**COMMISSION ACTION FORM**

**REQUEST: MAJOR SITE DEVELOPMENT PLAN FOR 2135 COTTONWOOD ROAD**

# Attachment B: Major Site Development Plan (Grading & Storm Sewer)

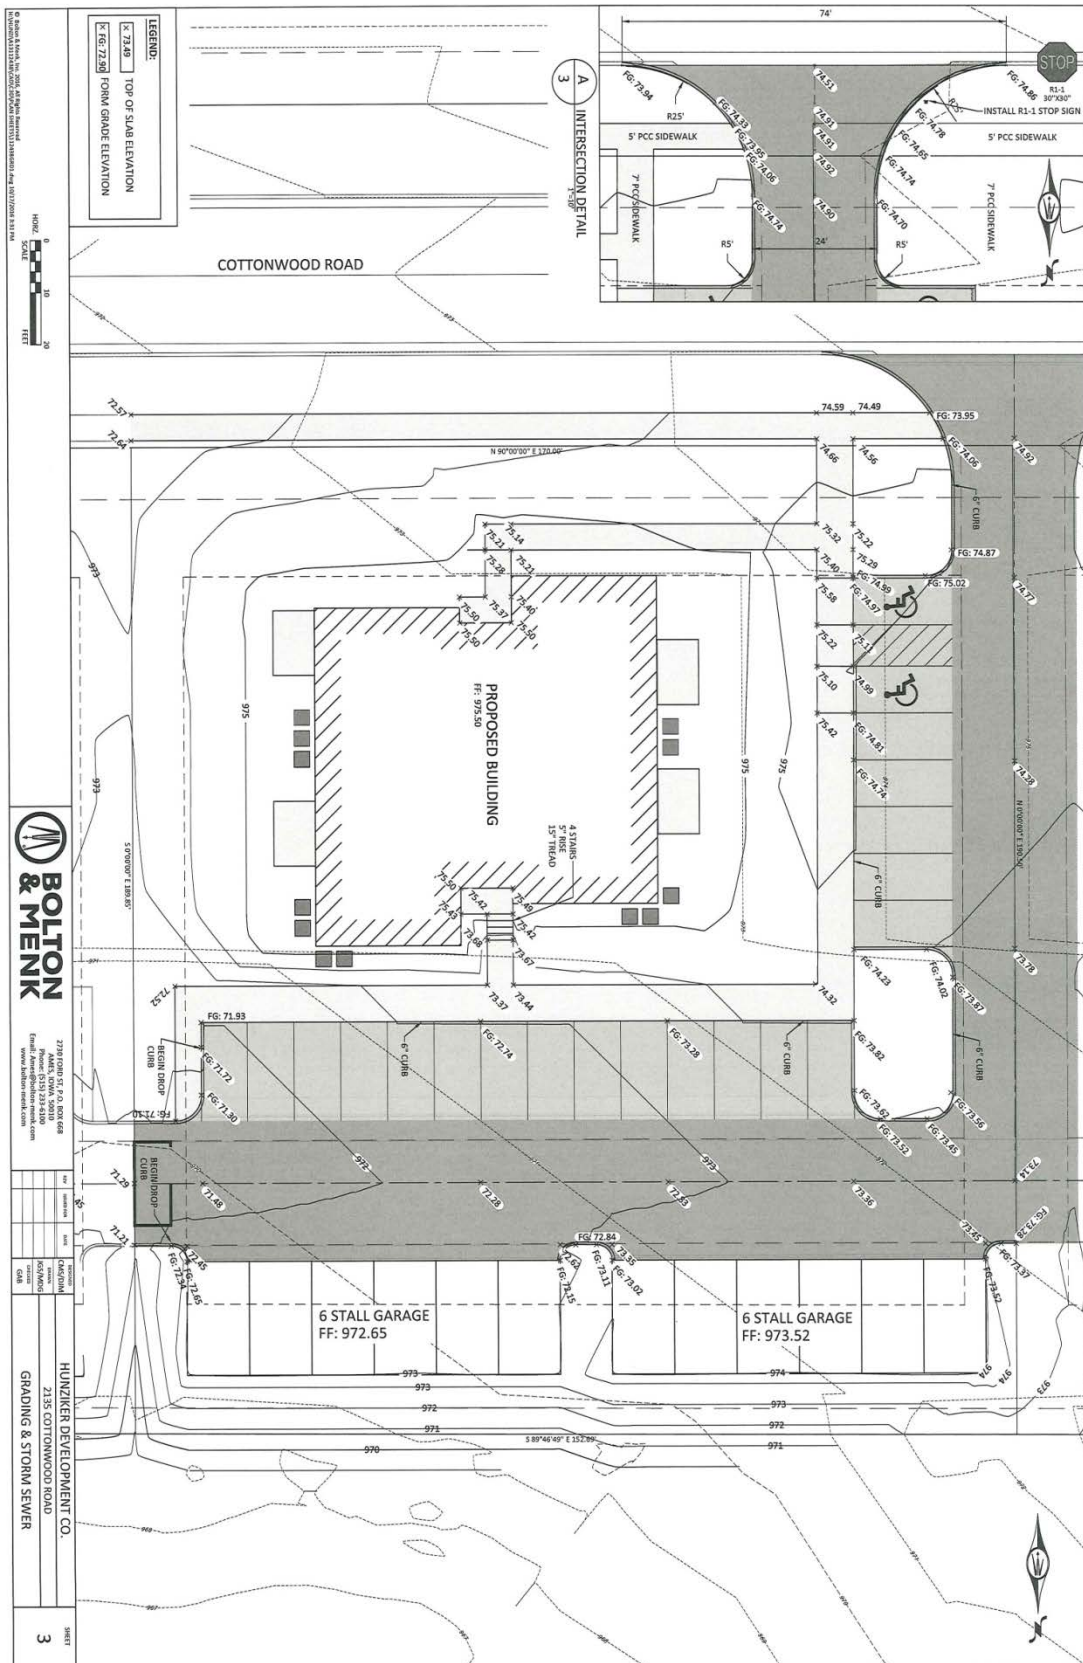
The Public Works Department has reviewed the storm water management plan and finds that the proposed development has met the required storm water quantity and quality measures by use of the proposed regional detention facilities on the southeast and northeast areas of the site.
